STATE OF MARYLAND PERMIT TO DRILL WELL

MEMORANDUM

RE: File Number: F-06-075
Title: Sharp Property Lot 1 and Preservation Parcels A and B
13950 Monticello Dr.

RECORD OF INVESTIGATION

LOCATION DIAGRAM

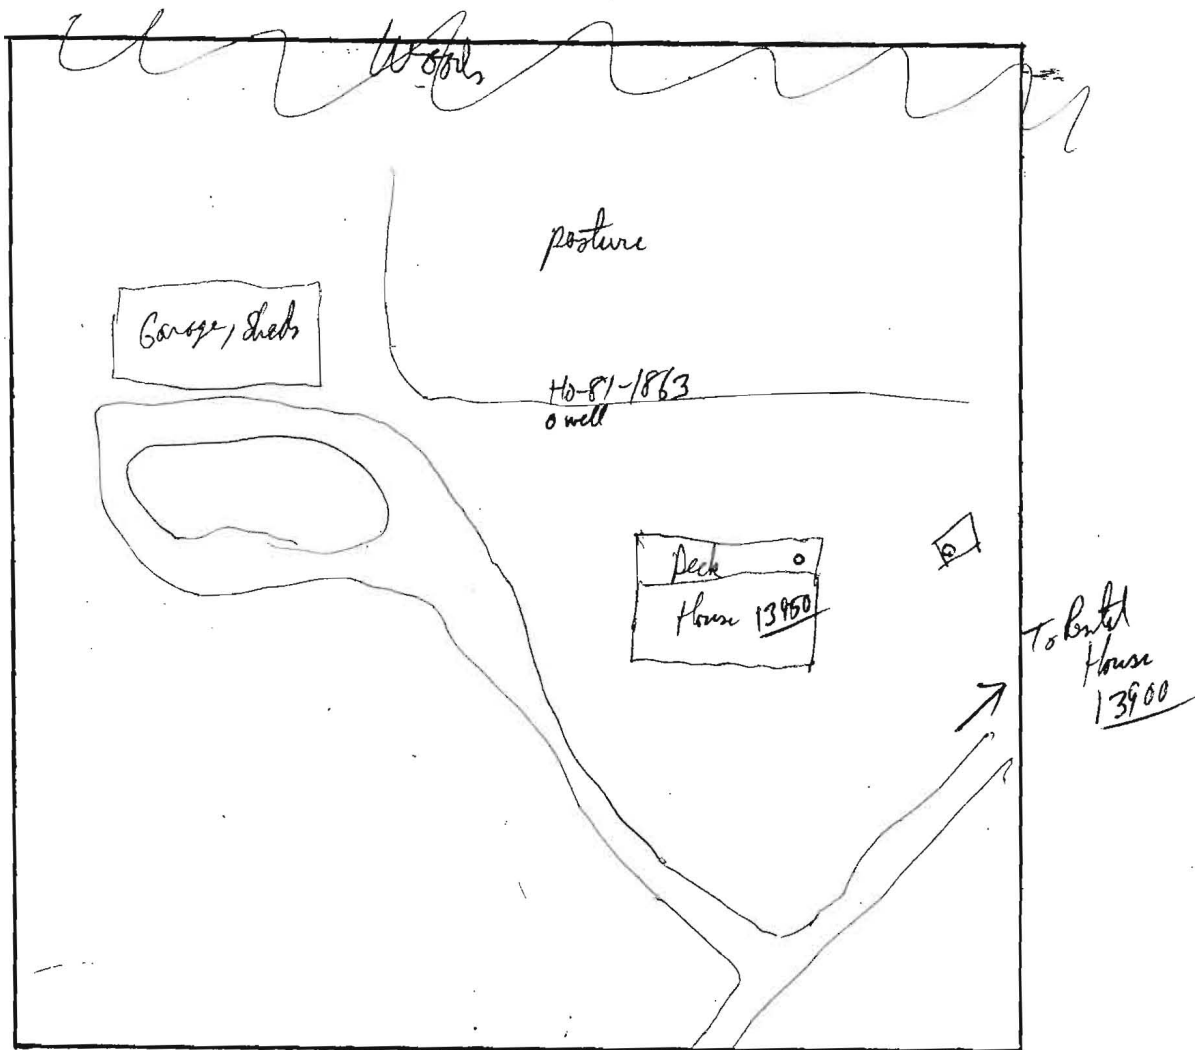
COMMENTS: Owner's complaint is brown iron rich water especially later hours of day (water is clear in mornings) - they have all kinds of water doctor filters but can't resolve problem. Easterday will try to help owner to trouble shooting the filter set up. If all else fails we could either permit her to use 60 gpm well that served old trailer (in Harbor Manor lot 29 area) or let her drill another well. Date to be determined if necessary @ a later date.
